Sub: Manual for Ultrasonic testing of Rails and Welds (Revised 2012) -
Revised A & C Slip No. 3 of August, 2016

'Manual for Ultrasonic testing of rails & welds, (Revised-2012)'

Revised A & C Slip No. 3 of August, 2016

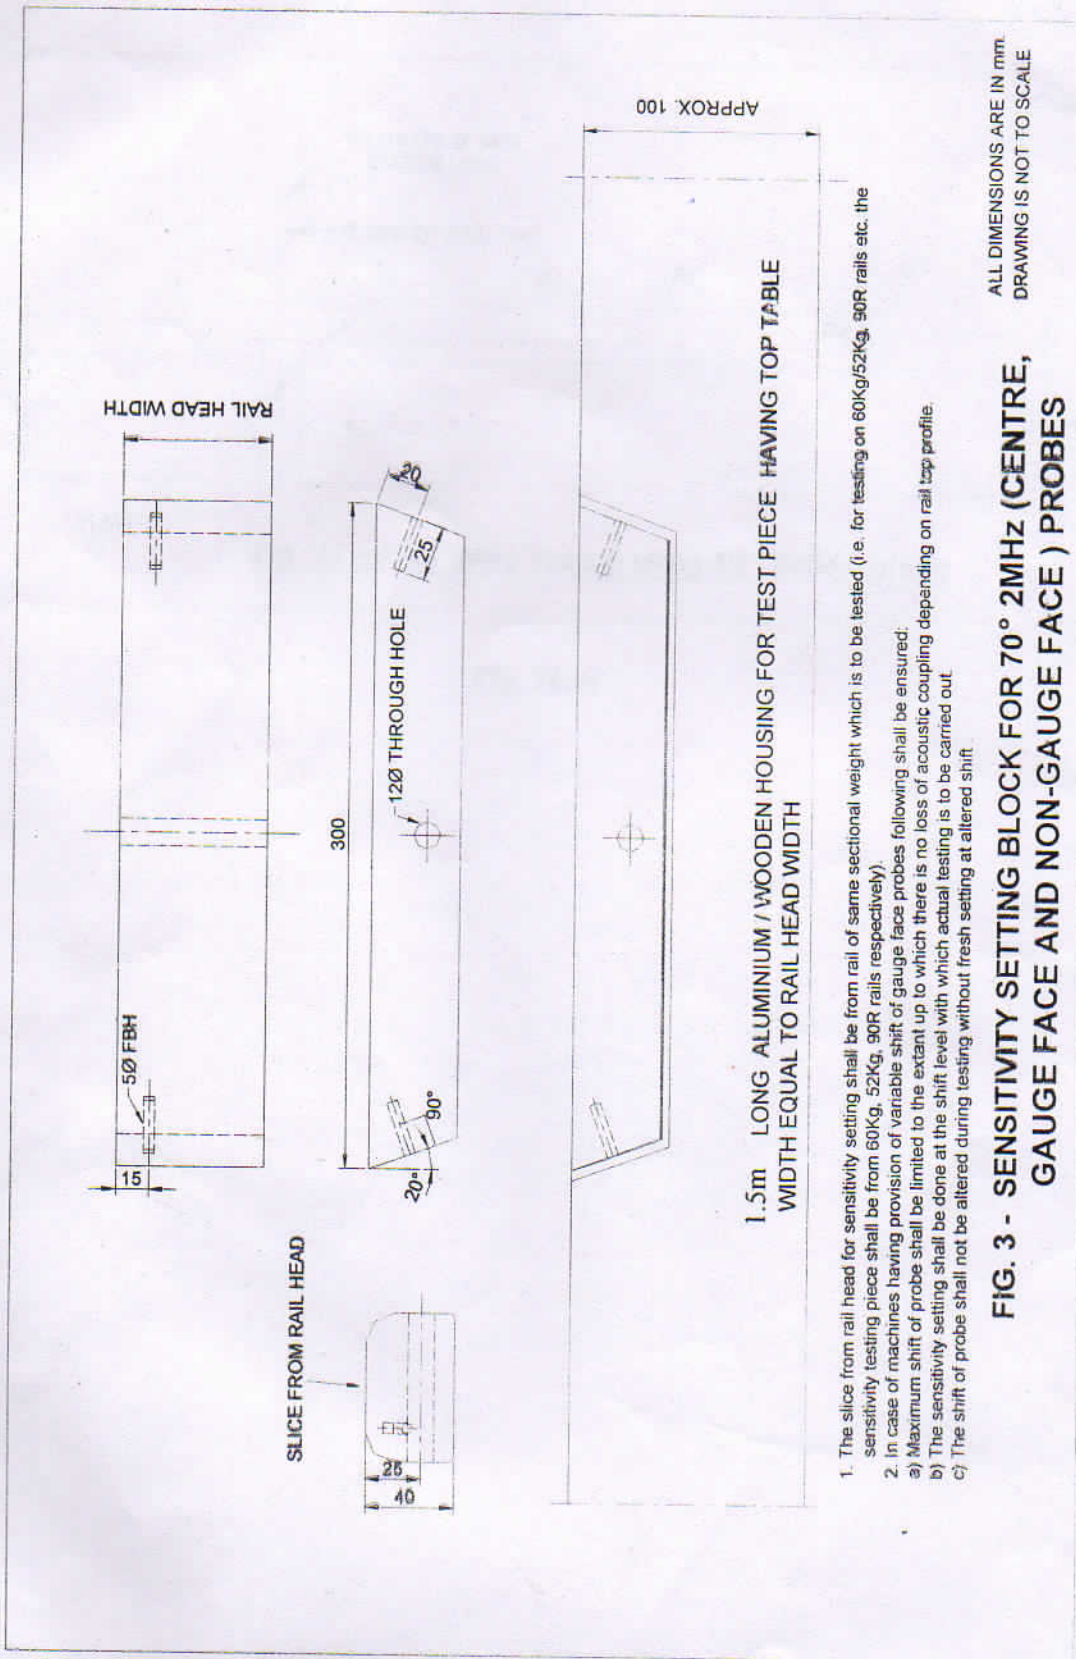
- i) Place the testing trolley on the standard rail piece having artificial flaws as shown in **Fig. 3** for need based criteria. Check the alignment of probes to make sure that 70° Central probe & 0° probe travel centrally in line with the axis of the rail head & web. 70° GF & 70° NGF probes shall be aligned towards GF & NGF respectively at appropriate positions.
- ii) Set the acoustic barrier of the normal probe at right angle to the longitudinal direction of rail.
- iii) Open the water nozzle and regulate water flow on the probes at an optimum speed.
- iv) While testing on single line section and 'D' marked rails on double / multiple line section, additional gain of 10db is to be employed."

9. Fig.3 and Fig.22 (c) are revised and are enclosed at Annexure-1-A and Annexure-1-B.
